**IN THE DRAWINGS:**

Attachments: Replacement Sheet  
Annotated Sheet Showing Changes  
2<sup>nd</sup> Replacement Sheet

Fig. 1

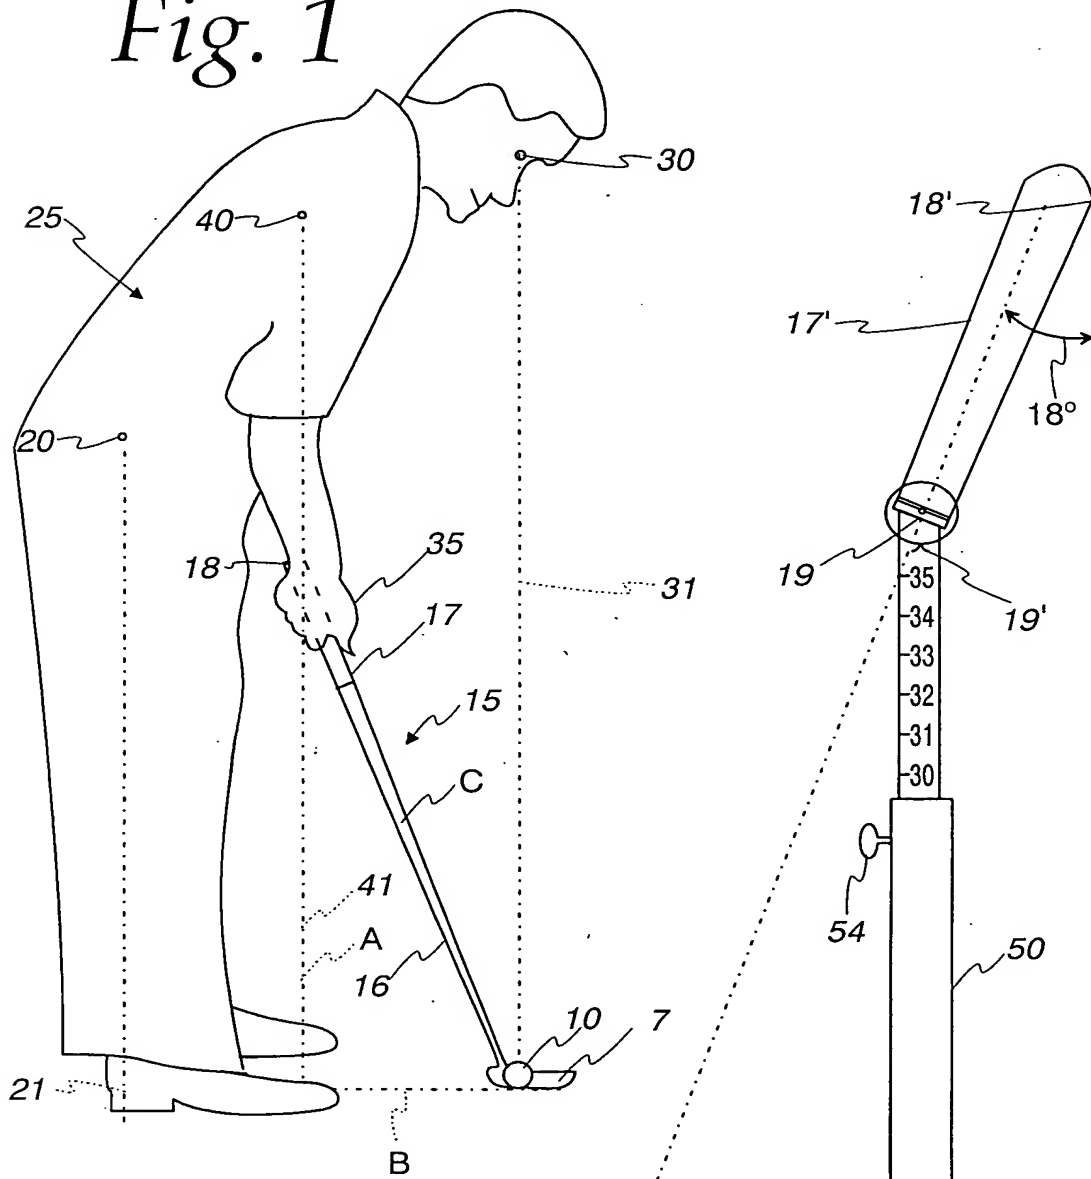
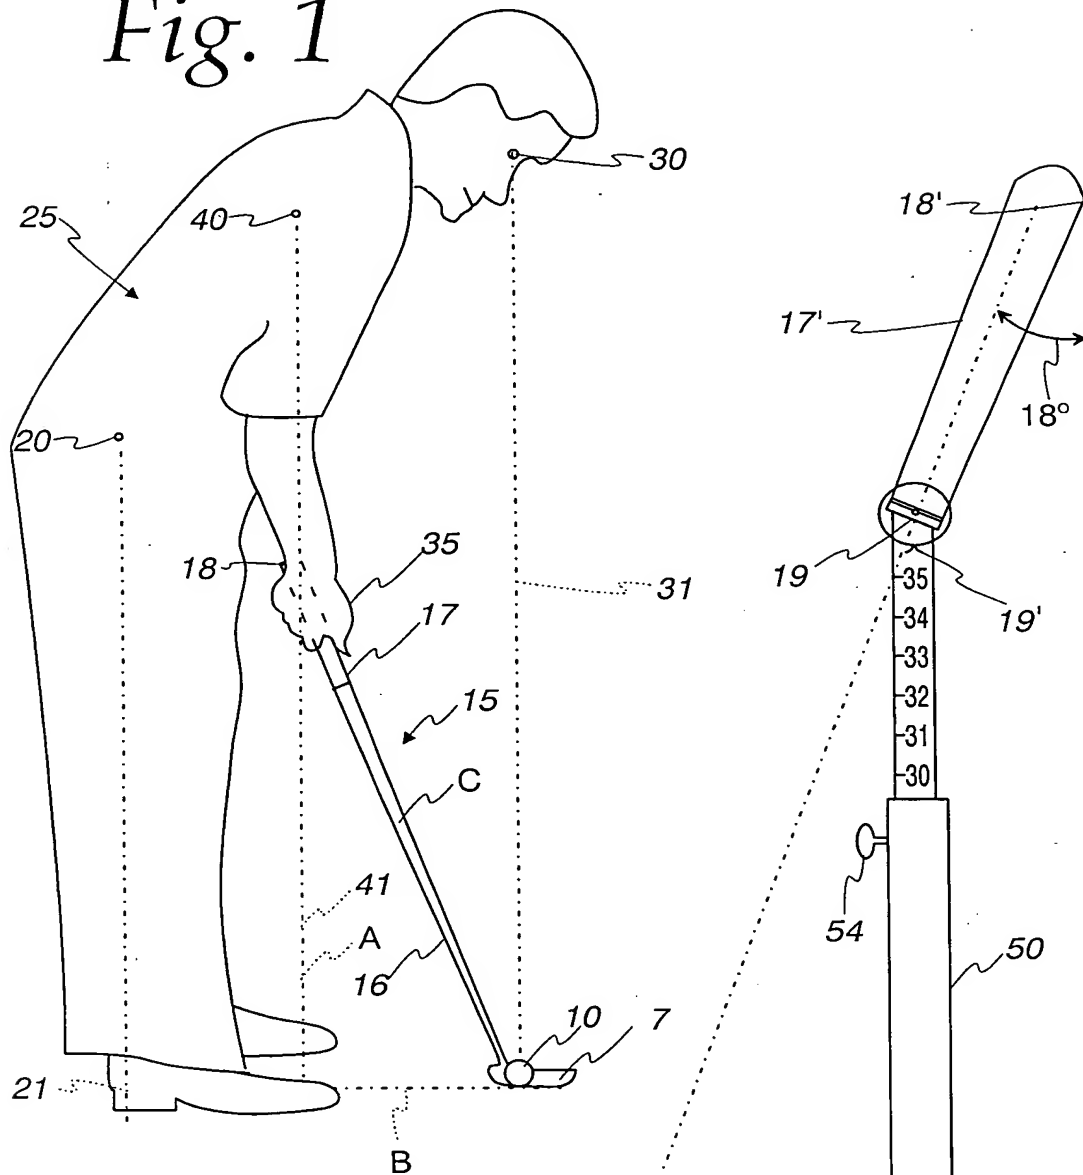
Please revise the drawing discussed above by changing "69°" to "75°"—and "75°" to "69°" on the lower horizontal arm 42, as illustrated in the attached sketch. A second substitute sheet of drawings incorporating this change is also attached herewith.
